IN THE MATTER of a private plan change for the rezoning approximately 7ha of land at 157 Levi Road, Rolleston, from Medium Density Residential Zone to Large Format Retail Zone (Variation 2) by Foodstuffs (South Island) Properties Limited

STATEMENT OF EVIDENCE OF ANDREW DAVID CARR

- 1.9 I was engaged by Council in May 2024 to undertake a peer review of the Integrated Transportation Assessment (**ITA**) of consultants Stantec that accompanied the plan change request (**Variation 2**) to identify areas of omission or which required clarification. I then reviewed the response received (**RFI Response**) to confirm that all matters I raised had been responded to.

Figure 1: Outline Development Plans for the Site and Immediate Area

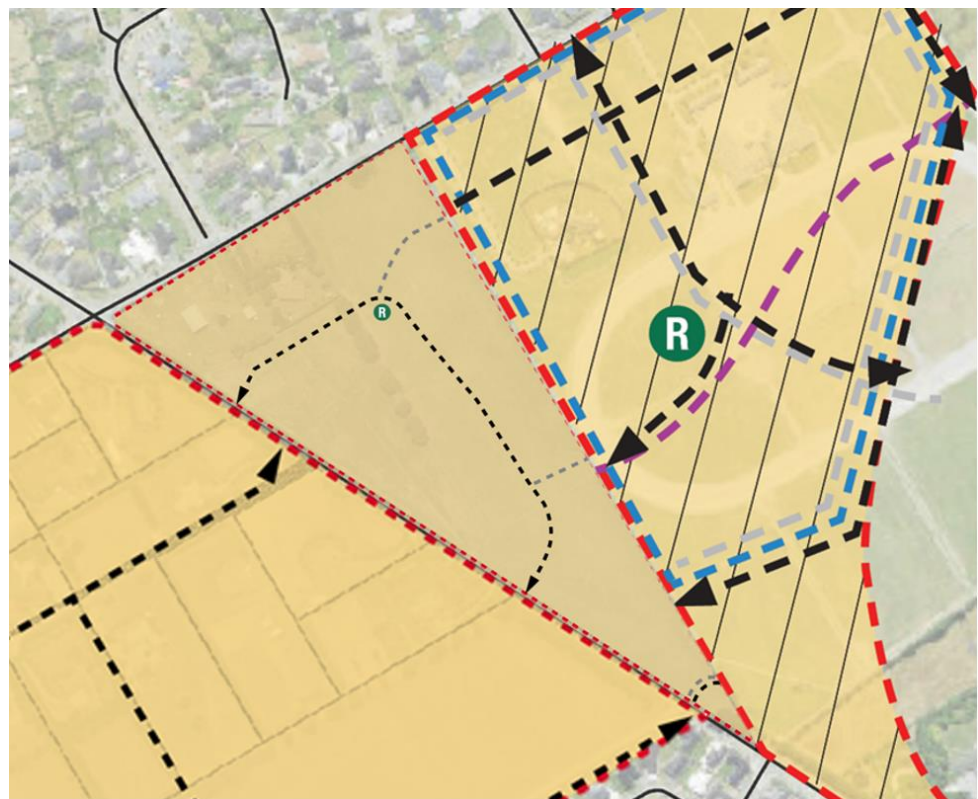
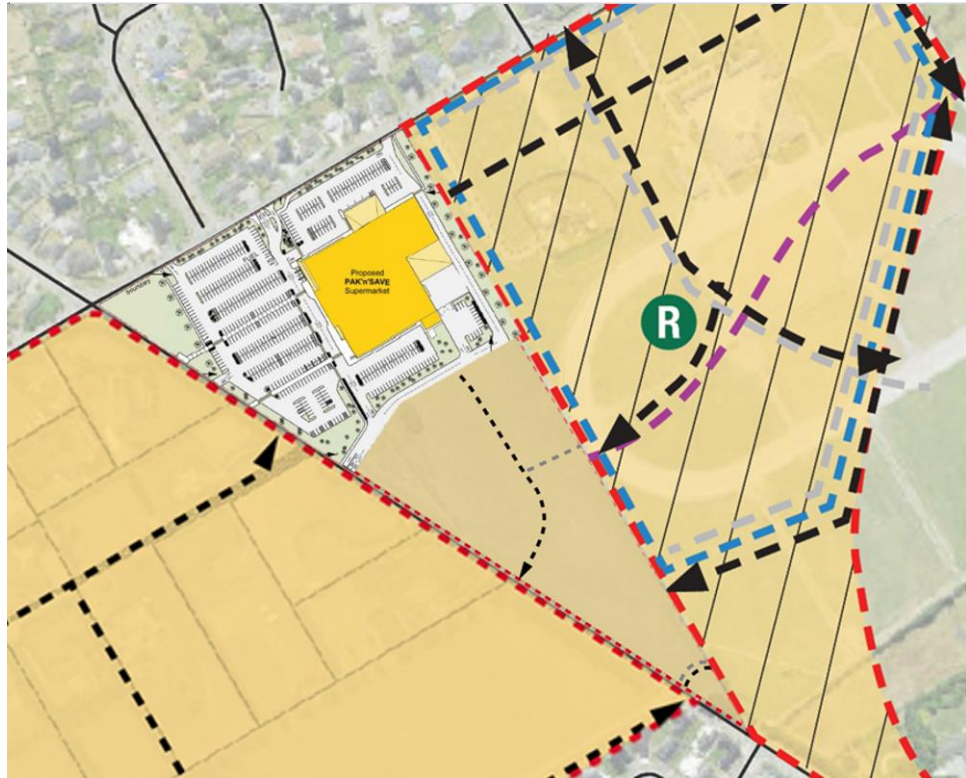
- 2.20 I note that the Pak n' Save site severs the northernmost east-west route between the site and the land to the east (ODP DEV-RO12). This matter was considered as part of the Pak n' Save hearing, where it was concluded that the layout was supportable because of other east-west roading connections. I discuss this subsequently.

**Figure 2: Outline Development Plans for Site and Immediate Area
Plus Pak n' Save**

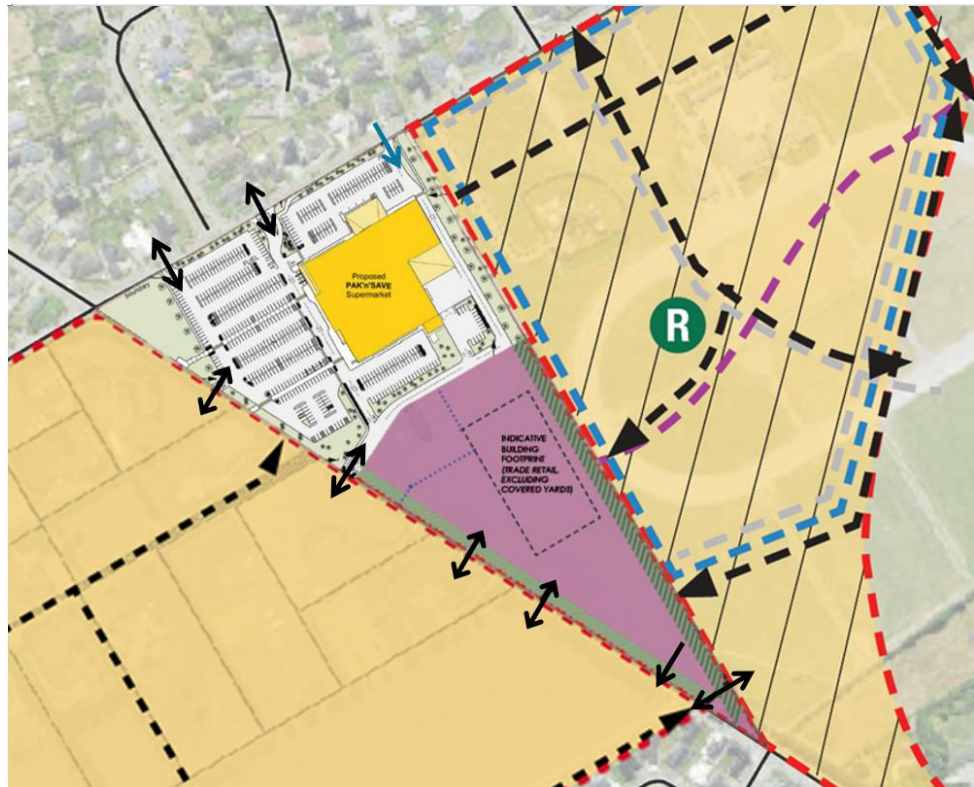
- 2.23 I note that the indicated northern points of access on the proposed ODP align with the consented Pak n' Save accesses (although for clarity, some of the accesses are shown as carrying two-way traffic when the Pak n' Save consent limited them to one-way operation). However the most substantial difference in my view is that the central east-west connection through the site is not proposed to be formed, but rather, would be obstructed through the location of the indicated trade supplier store.

- 2.47 Also within this part of the ITA is reference to the roading connectivity towards the south of the site. As shown on Figures 2 and 3 above, there is a roading connecting approaching Lincoln Rolleston Road from the west, and a connection through the south of the site, but with no corresponding roading connection further east. The ODP for the site maintains a roading connection in this location, with a service vehicle access located further north.

- 2.48 As I noted previously, the ODP removes the ability to form an east-west roading connection mid-way through the site to connect to land to the east (ODP DEV-RO12). This matter was considered as part of the Pak n' Save hearing, where it was concluded that the layout was supportable because of alternative route options – being the connection to the south of the site. No other east-west connections between the site and ODP DEV-RO12 were

- 2.49 With this in mind, I consider that it is a critical outcome of the proposed ODP that this east-west roading link is provided for. The ITA shows it to be in a location 'to be determined' but if this was to move further north, it would potentially conflict with the service vehicle access. The ODP shows that the east-west link location is indicative, and I recommend that the service access is similarly annotated.

- (a) A non-car east-west link should be show on the ODP to connect the site to the land to the immediate east;
 - (b) The vehicle crossings associated with Pak n' Save on the ODP should be updated to reflect that some carry one-way traffic only;

- (c) The service access to the south should be annotated on the ODP as being in an indicative location only, due to uncertainties around the location of the future Broadlands Drive roundabout;
